REBUTTAL PROOF

James McMahon in relation to the Proof
of

C R Barson and J M Whittingham, 119 Macclesfield Road, Hazel Grove
The Metropolitan Borough Council of Stockport
acting on its behalf and on behalf of
-Manchester City Council -and-
Cheshire East Borough Council

THE METROPOLITAN BOROUGH OF STOCKPORT (HAZEL GROVE (A6) TO
MANCHESTER AIRPORT A555 CLASSIFIED ROAD) COMPULSORY PURCHASE
ORDER 2013

Appendix A Existing Access Plan (1007_3D_DF7_A6-MA_GA_MR_335_C)

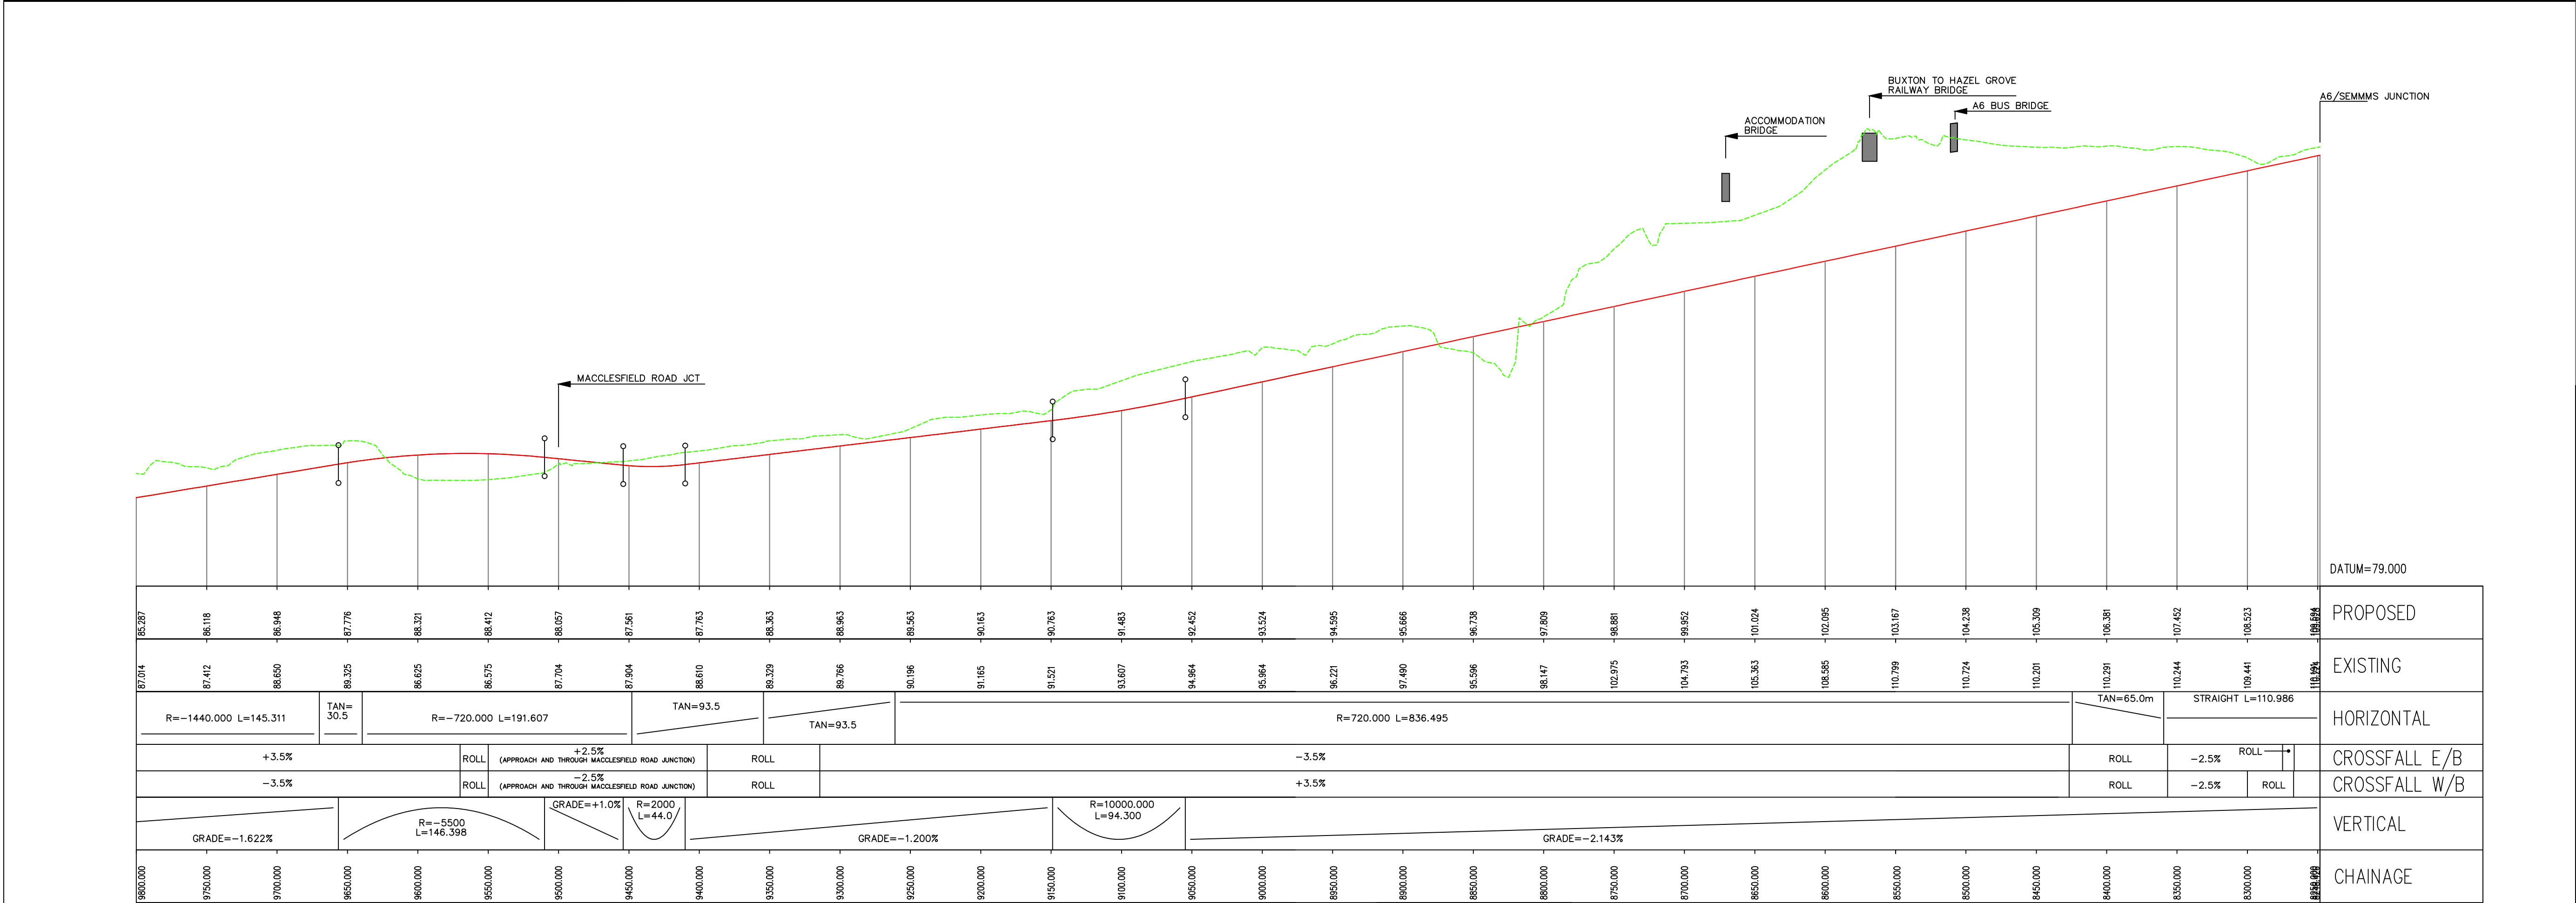
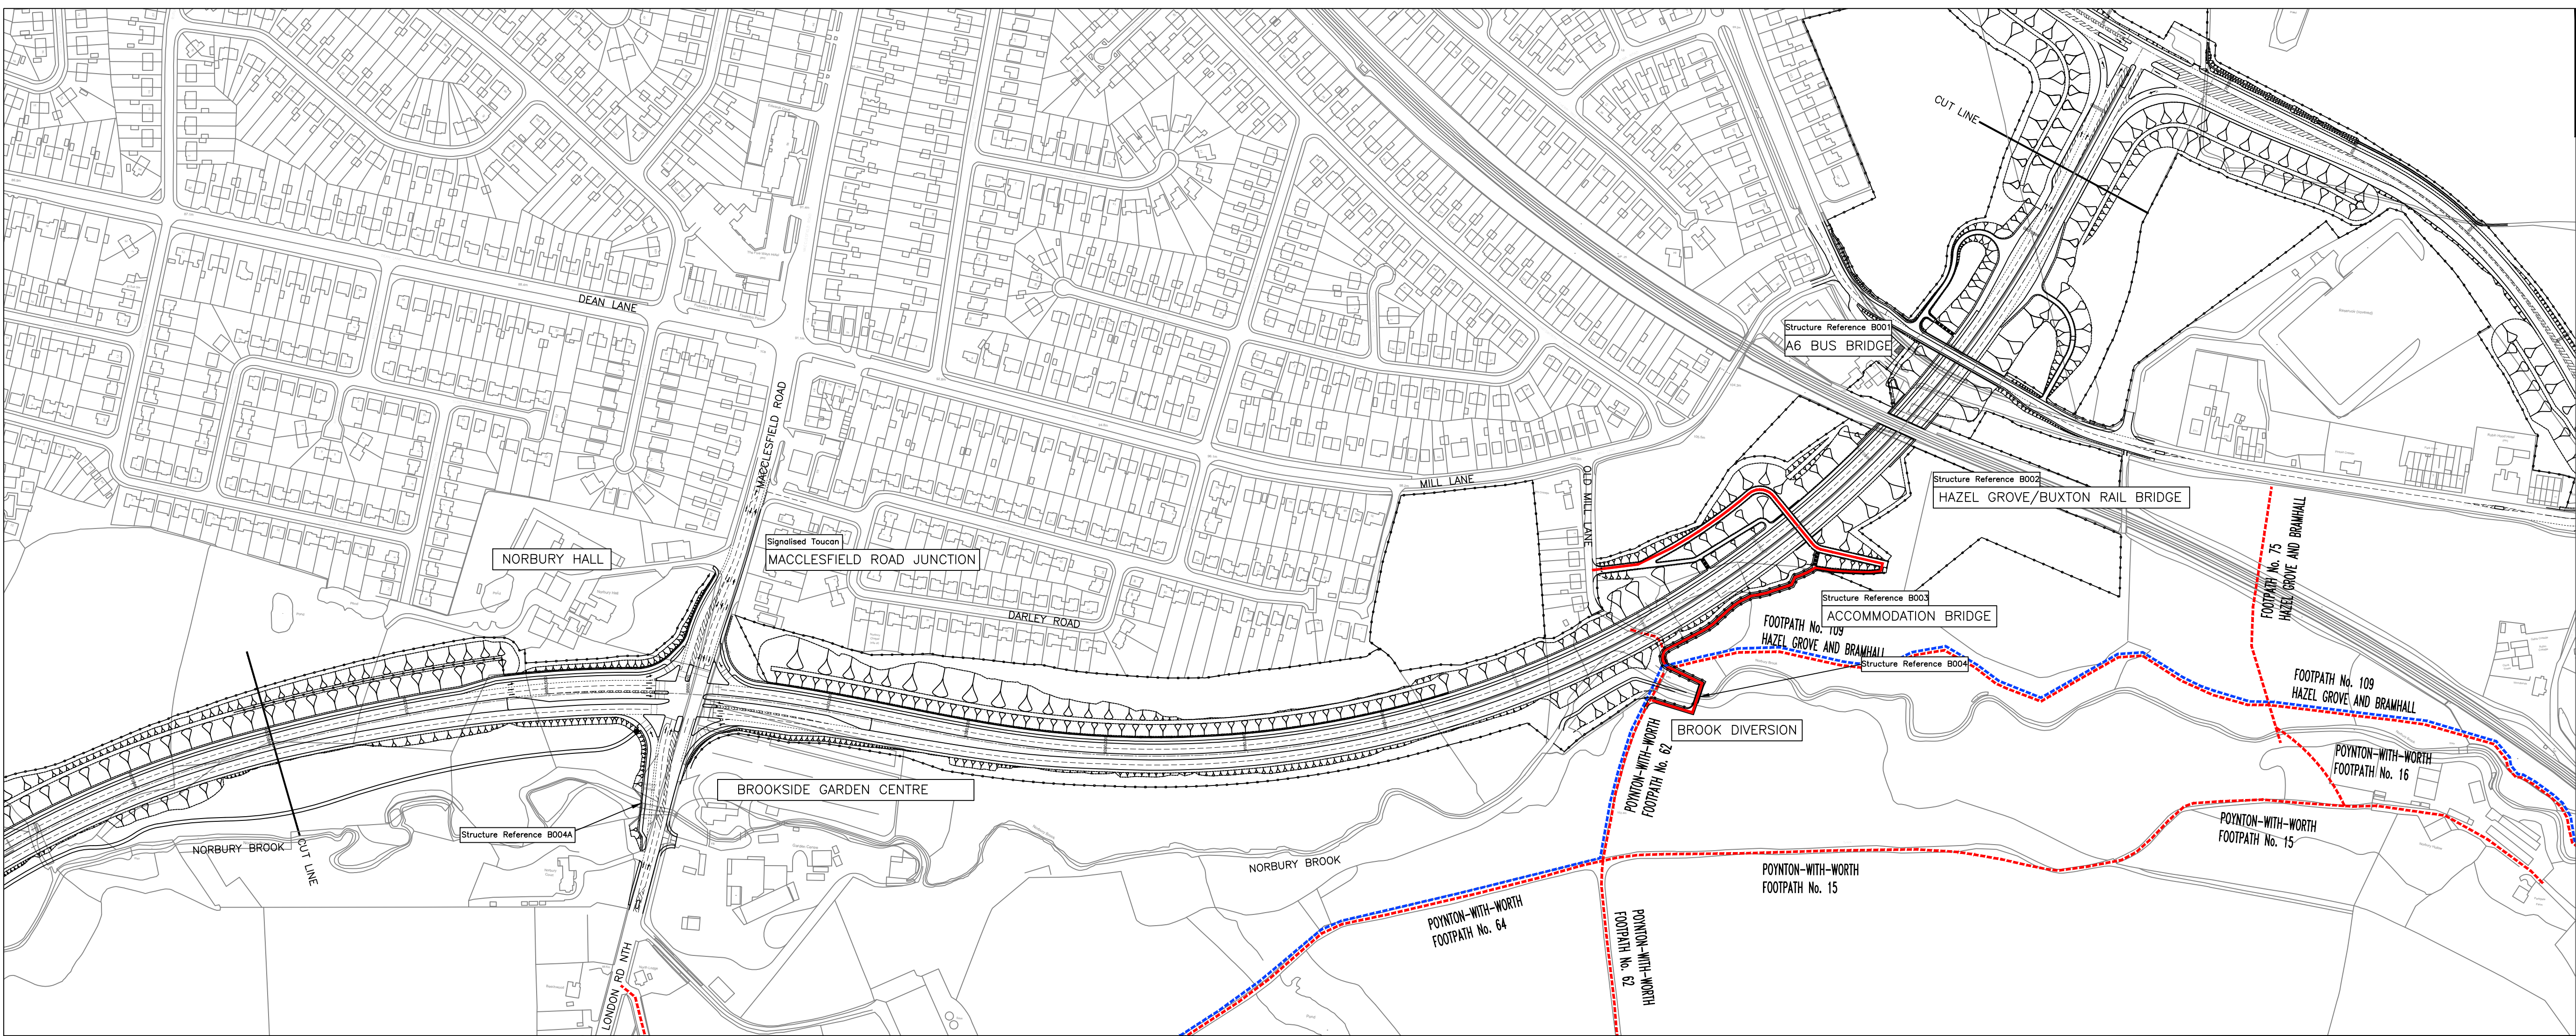
14/R02	<p>The fact sadly remains that the officers have failed to address genuine concerns of the residents as to the safety they feel this new junction will bring about.</p> <p>Residents, ourselves included fear for the future with a 5 lane road and slip road passing close by. The only response we</p>	<p>The approved layout is shown on the drawing 1007_3D_DF7_A6-MA_GA_202 General Arrangement Sheet 2 (Appendix B).</p> <p>The design of the layout has been developed to consider the impacts and concerns as noted by the residents. A layout was therefore developed as indicated on drawing</p>	NH

14/R03	<p>Clarity: It is clear that the Council has made changes to the originally submitted layout drawings as the plan given to you by Stockport Highways has an additional traffic island located on the northern Macclesfield Road arm of the junction, and therefore the junction is wider than suggested on the planning application drawings. The island is designed to segregate the right turn from Macclesfield Road onto the westbound SEMMMS route</p>	<p>See response to 14/R02.</p>	NH

<p>have had is 'well what would make it safer'. As we as a collective of people don't have training in road design this proved to be a futile exercise.</p>	<p>1007/3D/DF7/A6-MA/GA/MR/335/C (Appendix A) indicating the additional southbound lane at the proposed stop line to the traffic signals. It should be noted that the carriageway width is proposed to be widened to the same extent as the approved planning application design outside the property of the objector.</p> <p>It should also be noted that the updated design option requires no further increase in the Compulsory Purchase Order extents nor does it extend beyond the planning consent boundary.</p> <p>The junction layouts are subject to an independent Road Safety Audits in accordance with Council's Procedures and the Design manual for Roads and Bridge. This is further dealt with in 14/R04.</p> <p>Considering the above design guidance, Road Safety Audit comments and proposed updated design, it is the Council's opinion that the manoeuvre of reversing into the driveway of the objector's property is not precluded. Furthermore, it is considered that the updated junction design is a safe junction in accordance with current design standards.</p>

C	JW	NH	22/09/14	FOR VISIBILITY SPAN SHOWN ON EXT TO
B	JW	NH	18/09/14	AMENDMENTS FOLLOWING RSA 1
A	SEB	NH	16/07/14	LARGER AREA SHOWN
Rev.	Drawn	Checked	Date	Revision Details
